Modification to run CPU09CMI on 4MHz bus.

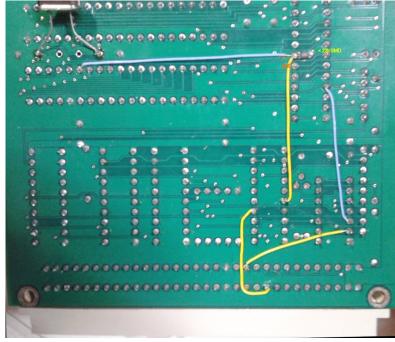
Replace xtal into 16MHz Replace GAL CMI_1 by CMI-4_1

On top side:

Cut trace between U4-14 and J1 C-21 (B_VMA) For REV:0.9 print only cut trace from J1 A23 (Gnd)

On solder side:

Cut trace between U13-19 and via (OVMA) Place 22K resistor between U13-19 and Gnd Place wire from U6-35 to U13-19 and U4-6 (Q) Place wire from U4-14 to J1 A-23 (B_Q)

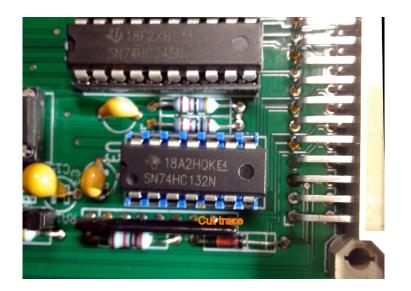
On top side:

Cut trace between U3-4 and U3-5

On solder side:

Place wire from U3-5 to U13-9 (VMA) Place wire from U3-6 to J1 C-21 (B_VMA)
